Planning Commission Staff Report Public Hearing June 8, 2023

#CUP2023-02 A request by CORE Electric Cooperative (Property Owner) and LKA Partners (Applicant) to approve a conditional use permit and site plan to renovate and expand the CORE Electric Cooperative facilities in the Community Commercial (CC) zone. The subject property is located at 800 N. Hwy 67 and is known as Lot 1R Carey Subdivision No. 2, City of Woodland Park, Teller County, Colorado. (QJ)

Site Plan
 SP1.0

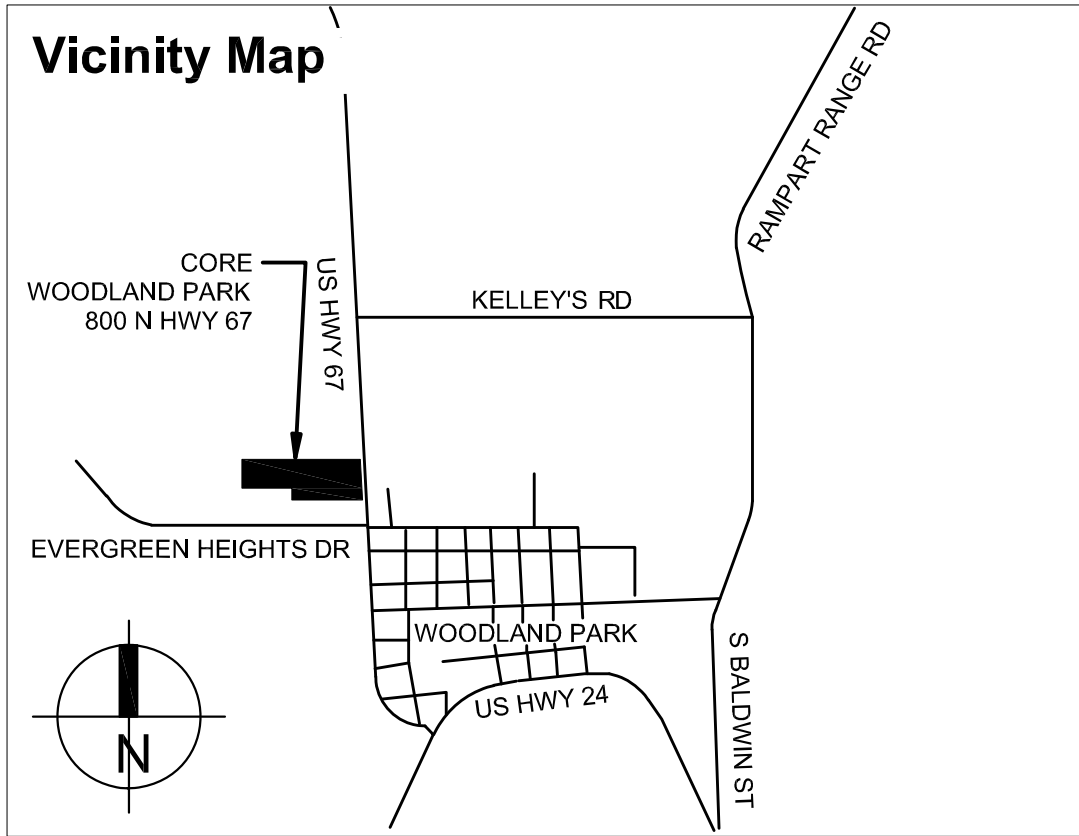
Page Label	Comments	Reviewer
SP1.0	Please include a snow storage exhibit within this plan set	Cgates
SPG1	CWP DM 7.1 In general, storm drain alignments between drainage structures (inlets or manholes) shall be straight.	Skozurek
SPU1	Sanitary sewer clean-outs required, CWP ES 3.3.7	Ksimpkins
SPU1	CWP ES 3.1.7 Changes in alignment for service lines shall be accomplished with preformed bends not to exceed 45 degrees. When changes of direction exceed 45 degrees, a two (2') foot section of pipe shall separate the fittings necessary to make the needed change of direction	Skozurek
SPU1	Please Show Valves	Skozurek
SPU1	Profile plan is required on all water main extensions. Please identify the crossing with the storm sewer line and the vertical separation	Kwiley
SPU1	Water shut off valve is needed. Also, can the gate be relocate so the City can access the water shut off valve. If not, the tap location will need to be relocate to point accessible by the City.	Kwiley
